PALO VERDE - UNIT 1

G. MARKED-UP TECHNICAL SPECIFICATION CHANGE PAGES

(see attached pages; VI, XVII, XVIII, XIX, 3/4 4-25, 3/4 4-26, 3/4 4-27, 3/4 4-28, 3/4 4-29, 3/4 4-30, 3/4 4-31, 3/4 4-32, 3/4 4-33, B 3/4 4-5, and 6-17)

FIGURE 3.4-1

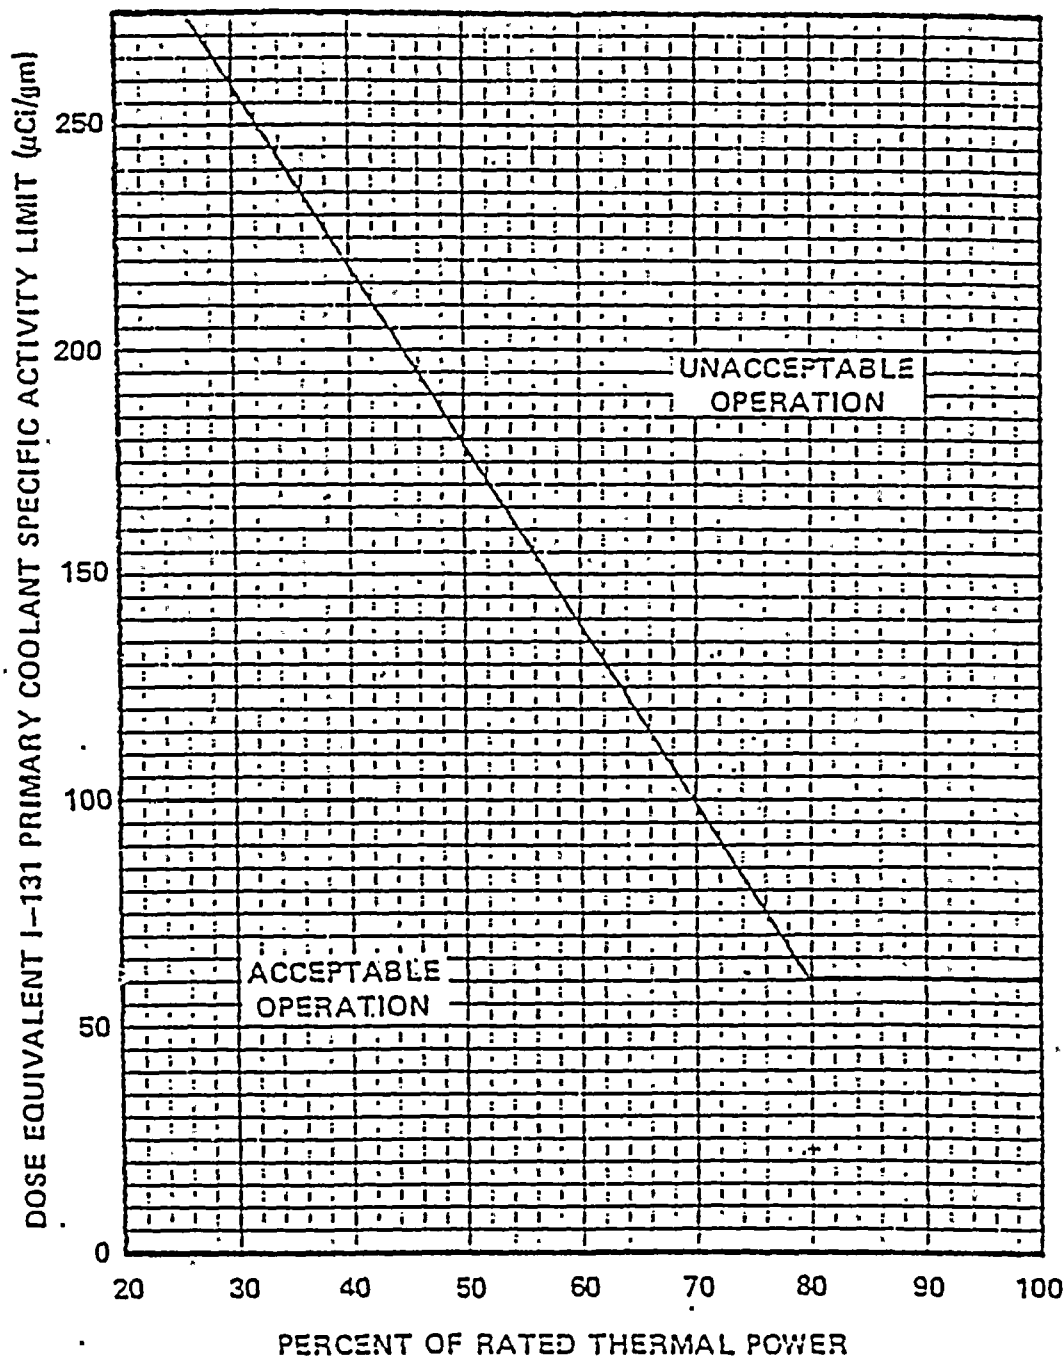
- a. With the specific activity of the primary coolant greater than 1.0 microcurie/gram DOSE EQUIVALENT I-131, but within the allowable limit (below and to the left of the line) shown on Figure 3.4-1, operation may continue for up to 48 hours provided that the cumulative operating time under these circumstances does not exceed 800 hours in any consecutive 12-month period. With the total cumulative operating time at a primary coolant specific activity greater than 1.0 microcurie/gram DOSE EQUIVALENT I-131 exceeding 500 hours in any consecutive 6-month period, prepare and submit a Special Report to the Commission pursuant to Specification 6.9.2 within 30 days indicating the number of hours above this limit. The provisions of Specification 3.0.4 are not applicable.

- b.  $100/\bar{E}$  With the specific activity of the primary coolant greater than  $1.0$  microcurie/gram DOSE EQUIVALENT I-131 for more than 48 hours during one continuous time interval or exceeding the limit line shown on Figure 3.4-1, be in at least HOT STANDBY with  $T_{cold}$  less than  $500^{\circ}F$  within 6 hours.

- d. ~~With the specific activity of the primary coolant greater than 1 microcurie/gram DOSE EQUIVALENT I-131 or greater than 100/E microcuries/gram, perform the sampling and analysis requirements of item 4.(a) of Table 4.4-4 until the specific activity of the primary coolant is restored to within its limits. A Special Report shall be prepared and submitted to the Commission pursuant to Specification 6.9.2 within 30 days with a copy to the Director, Nuclear Reactor Regulation, Attention: Chief, Core Performance Branch, and Chief, Accident Evaluation Branch, U.S. Nuclear Regulatory Commission, Washington, D.C. 20555. This report shall contain the results of the specific activity analyses together with the following information:~~

Annual reports shall also include the results of specific activity analysis in which the primary coolant exceeded the limits of Specification 3.4.7. The following information shall be included: (1) Reactor power history starting 48 hours prior to the first sample in which the limit was exceeded; (2) Results of the last isotopic analysis for radioiodine performed prior to exceeding the limit, results of analysis while limit was exceeded and results of one analysis after the radioiodine activity was reduced to less than limit. Each result should include date and time of sampling and the radioiodine concentrations; (3) Clean-up system flow history starting 48 hours prior to the first sample in which the limit was exceeded; (4) Graph of the I-131 concentration and one other radioiodine isotope concentration in microcuries per gram as a function of time for the duration of the specific activity above the steady-state level; and (5) The time duration when the specific activity of the primary coolant exceeded the radioiodine limit.
